# Intel® 82443MX PCIset

## Specification Update

*April 2001*

**Figure 1: Successful Self-refresh Entry**

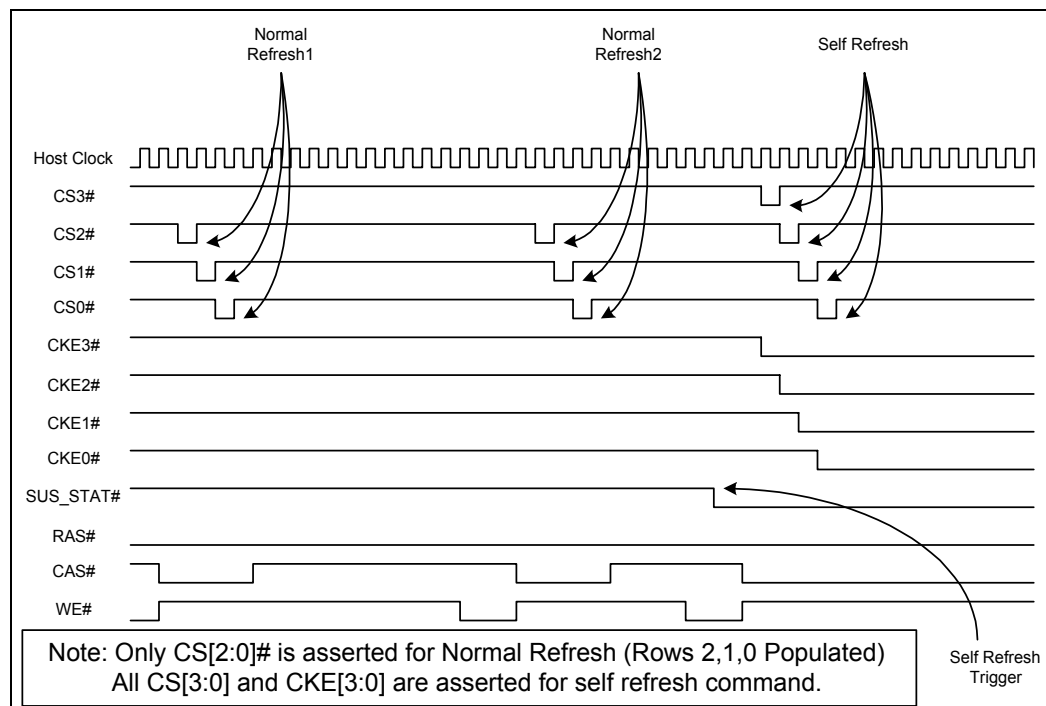
**Issue:** SDRAM may be prevented from being put into self-refresh state when a self-refresh entry request triggered by SUS\_STAT# assertion collides with a normal refresh caused by internal timer expiration. The collision between the two requests results in anomalous behavior on the CS[0-3]# and CKE[0-4]#, which can cause the system hang/memory corruption. There is a three Host clock window in which the assertion of SUS\_STAT# can cause this failure.

Figure 1 illustrates a successful suspend entry sequence for a system which has rows 0, 1, and 2 populated. Note that for normal refresh, only the chip selects for the populated rows are asserted,

whereas for the self-entry command, all four chip selects are asserted regardless of its population. Assume that dynamic SDRAM power-down feature is disabled. If all four rows are populated, it is impossible to capture this erratum.

**Workaround:** Please refer to the SDRAM Suspend Refresh Erratum APM Workaround Write-up, Rev 1.0 for a software workaround solution.

Figure 2: Unsuccessful Self-refresh Entry

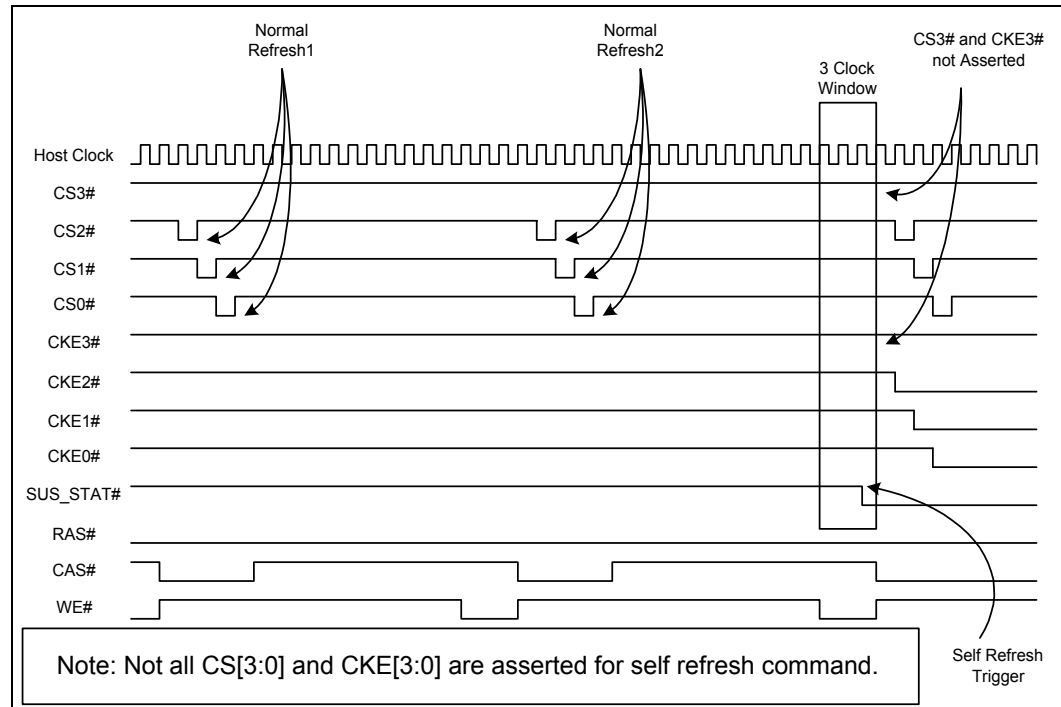
An unsuccessful self-refresh will exhibit the following characteristics:

1. SUS\_STAT# assertion is taking place around a normal refresh request.
2. CS# and CKE# signals are asserted only for the populated rows.

Figure 2 illustrates an unsuccessful self-refresh entry sequence. Note that SUS\_STAT# is being asserted approximately the same time that the third normal refresh would have taken place. Since the SUS\_STAT# assertion hits the three host clock window, CS3# and CKE3# do not get asserted during the self-refresh entry sequence.

**Implication:** The system may hang if an unsuccessful self refresh entry sequence occurs.
